BARANGAROO SOUTH

Stage 1B Public Domain Modification S4.55 Development Application Report

Mod Application Overview

HICKSON PARK LONG SECTIONS

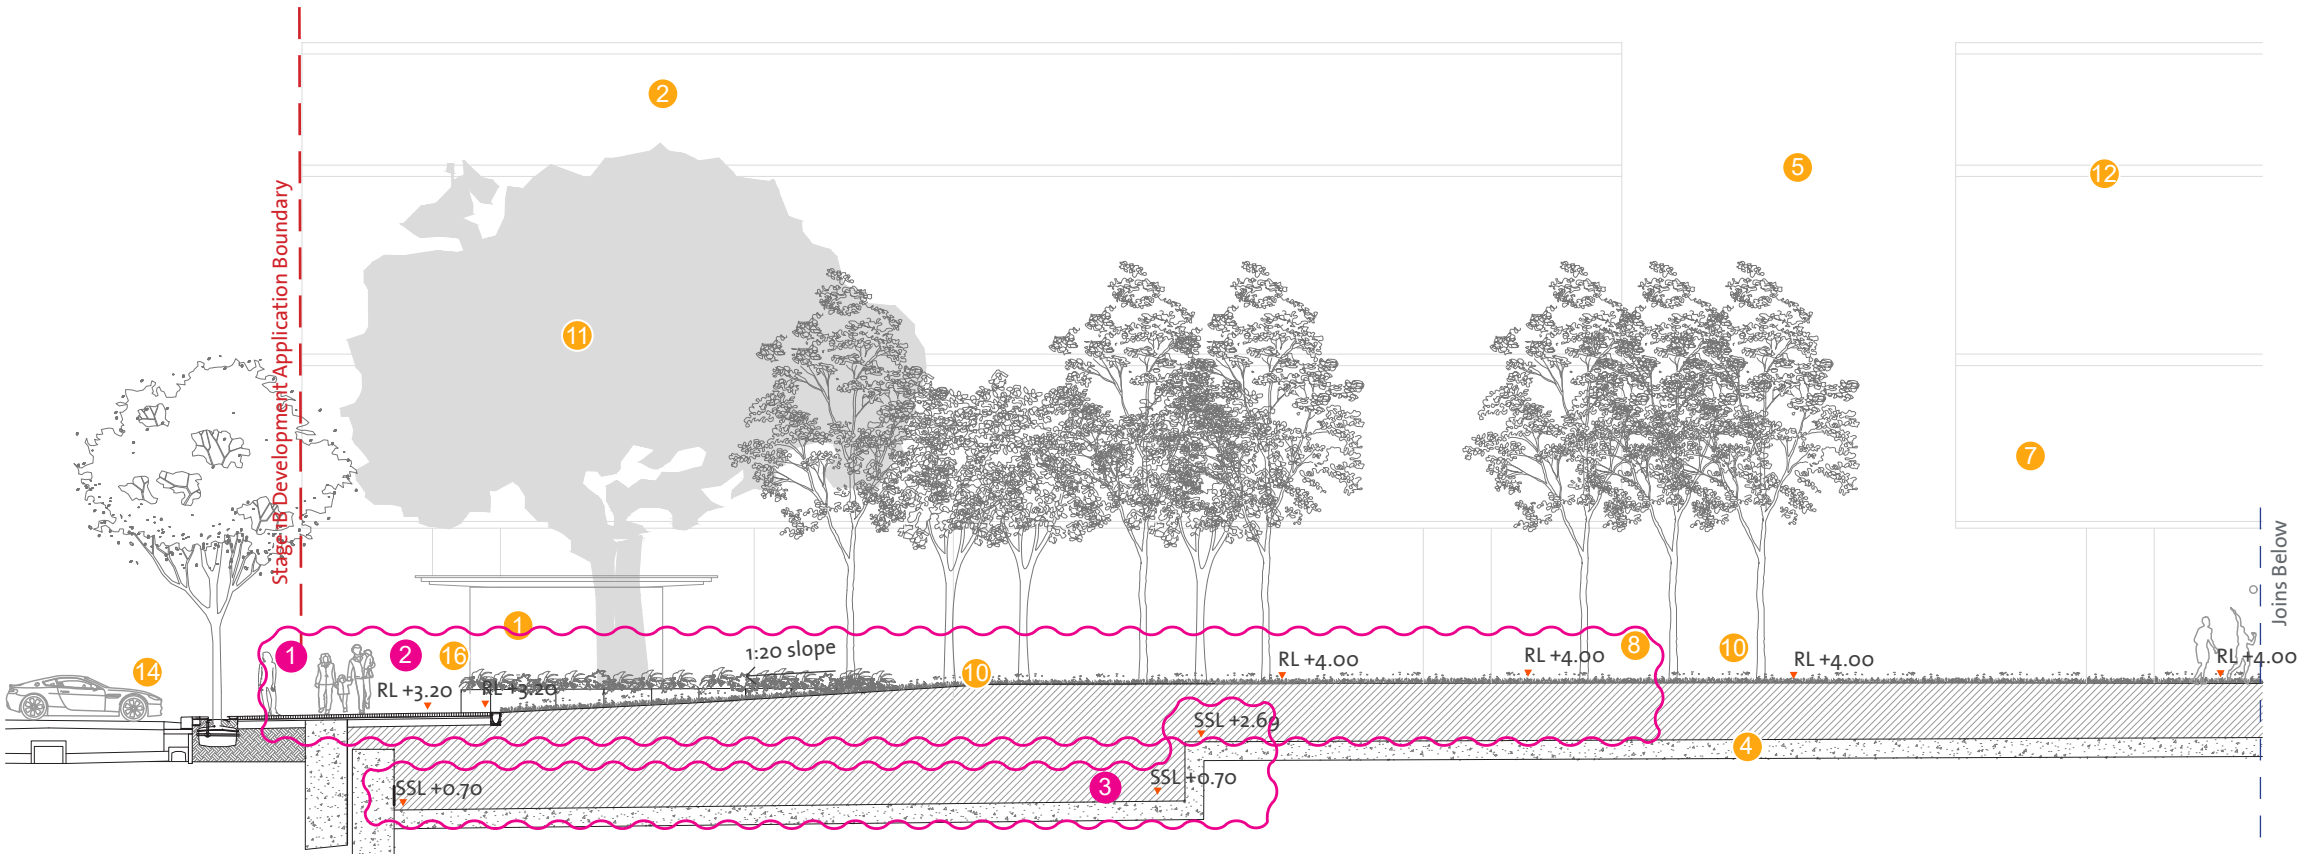
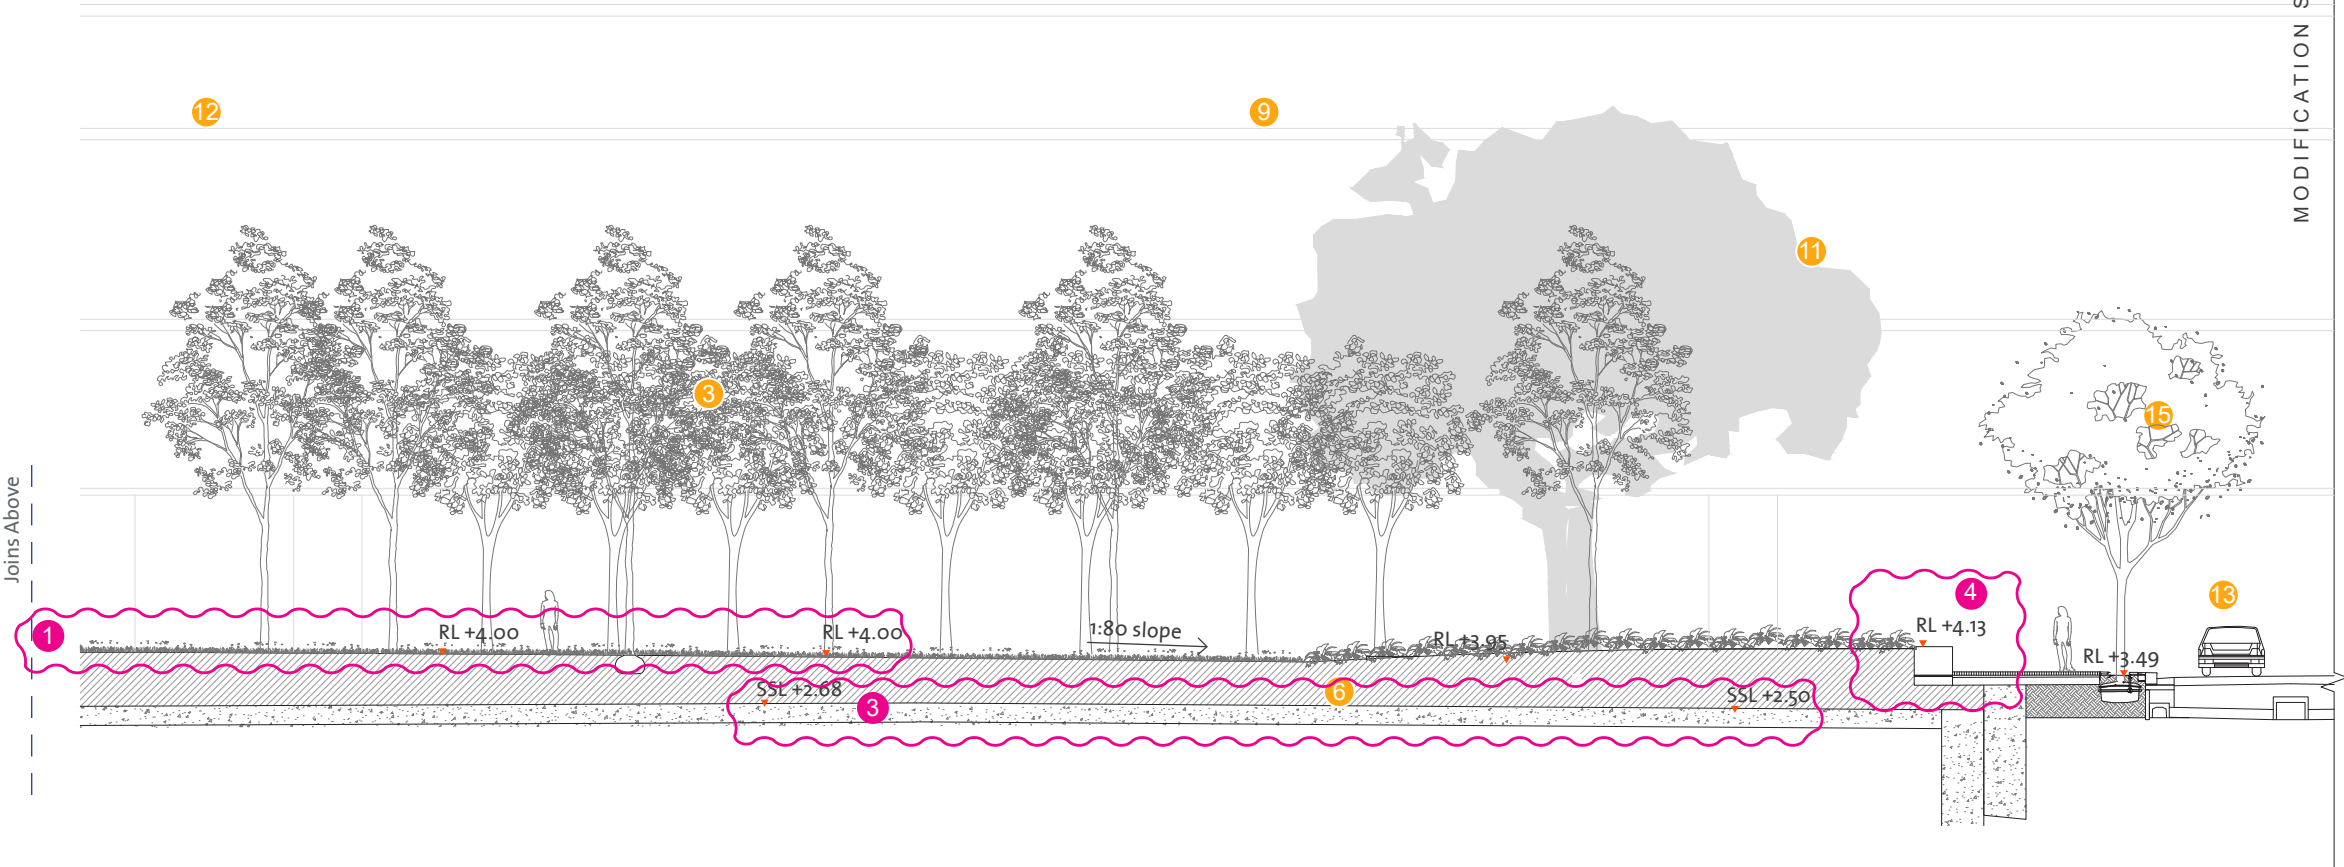
- Amendment cloud
- 1 Levels changed due to proposed Hickson Road levels
- 2 Sandstone bollards changed to concrete & delete bollards to East park edge.
- 3 Basement slab levels amended. Subject to Secretary Approval under the Basement application
- 4 Lower sandstone wall to 600mm height

HICKSON PARK LONG SECTIONS

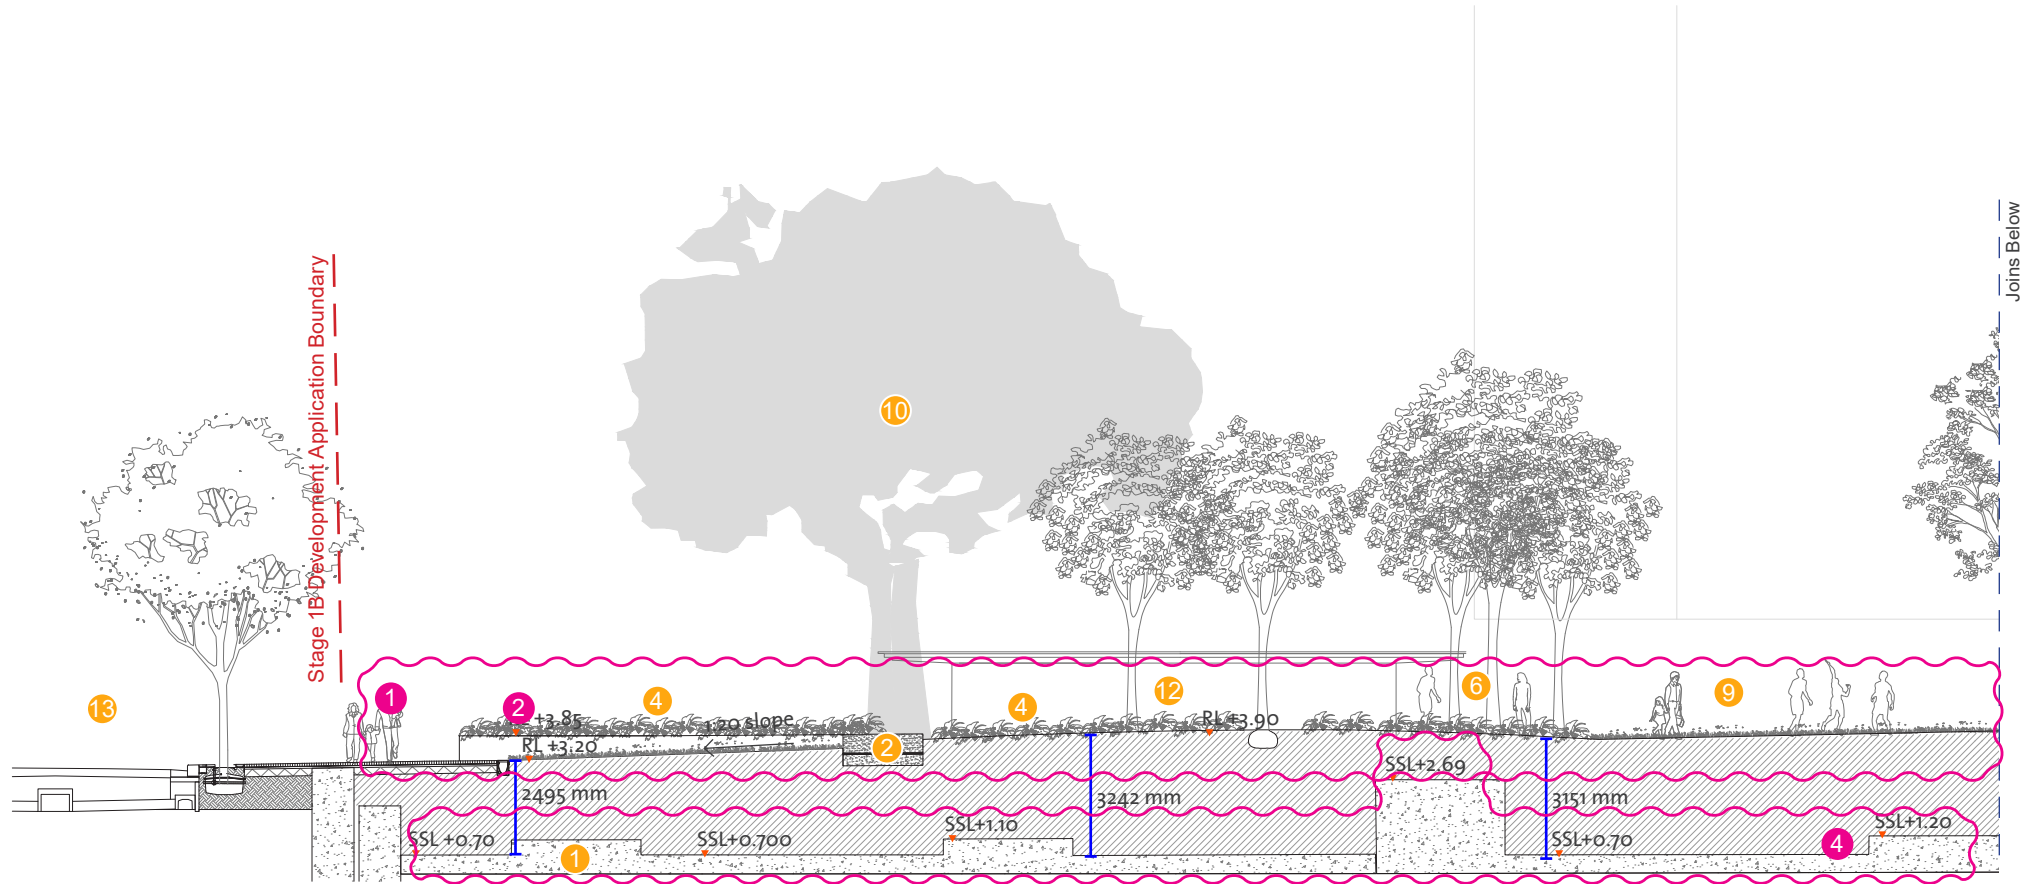
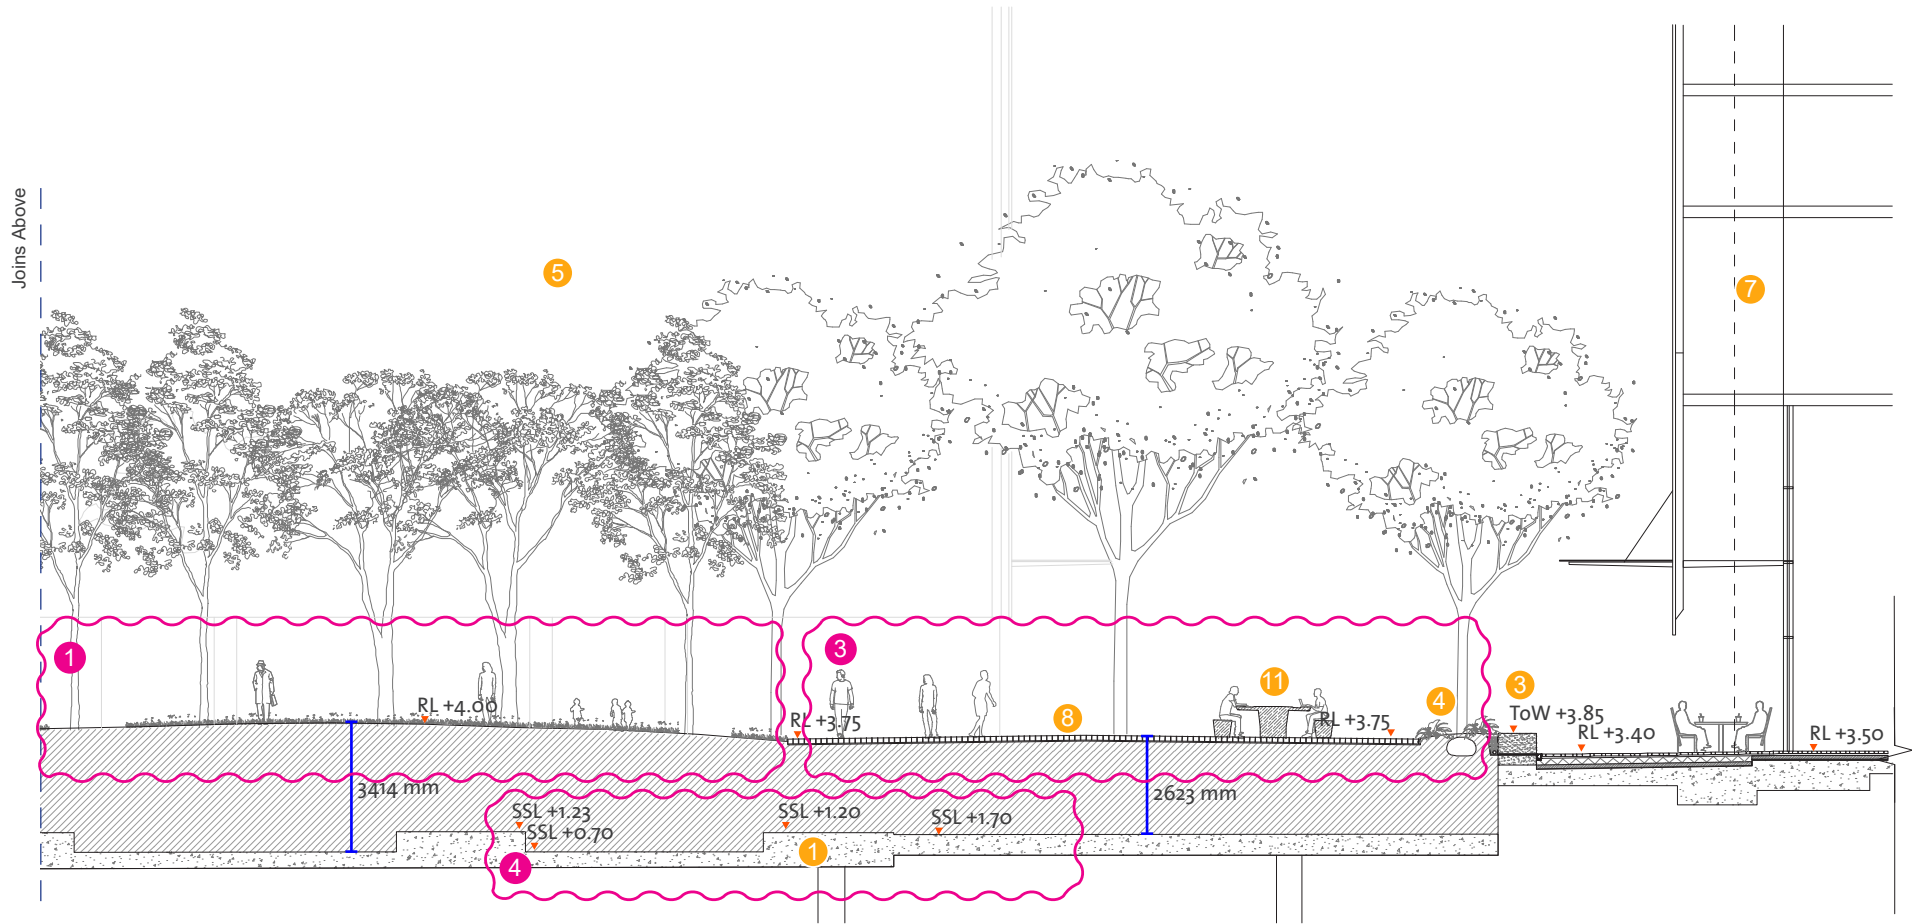
- Amendment cloud
- 1 Levels changed due to proposed Hickson Road levels
- 2 Sandstone bollards changed to concrete & delete bollards to East park edge.
- 3 Increase planting area within the park and change of geometry.
- 4 Basement slab levels amended. Subject to Secretary Approval under the Basement application

WULUGUL WALK MASTER PLAN

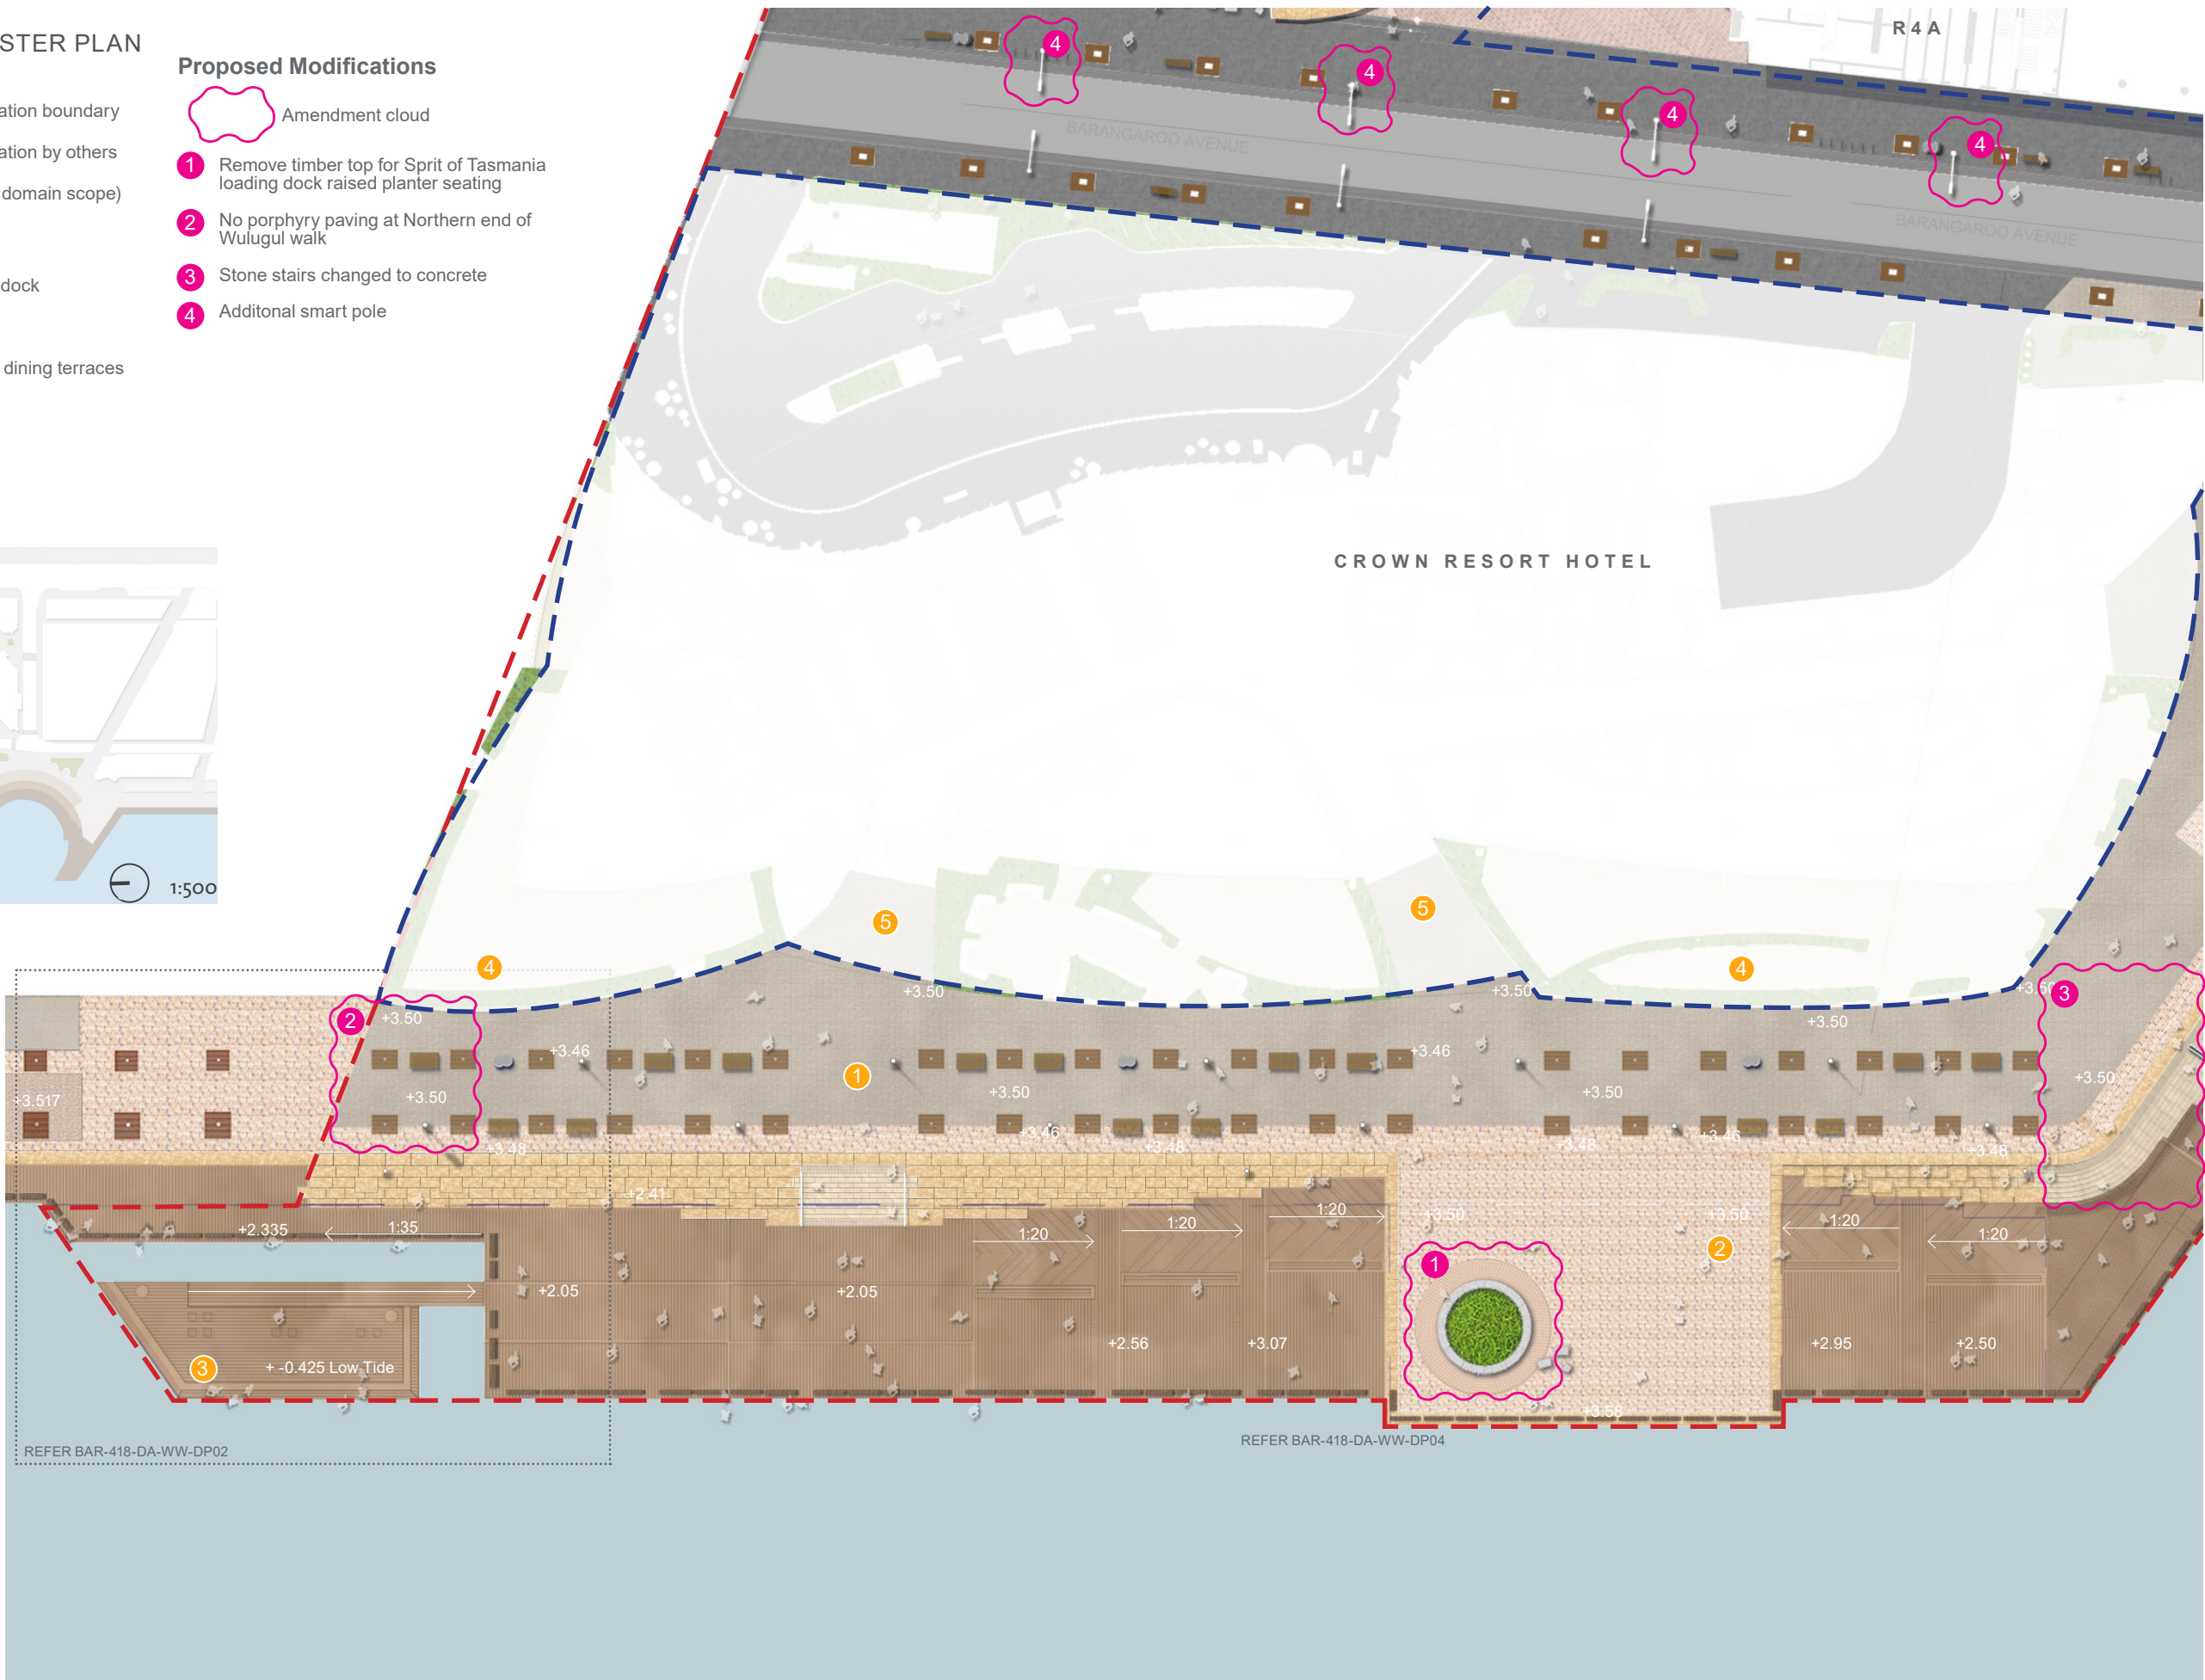
- Amendment cloud
- 1 Remove timber top for Sprit of Tasmania loading dock raised planter seating
- 2 No porphyry paving at Northern end of Wulugul walk
- 3 Stone stairs changed to concrete
- 4 Additional smart pole
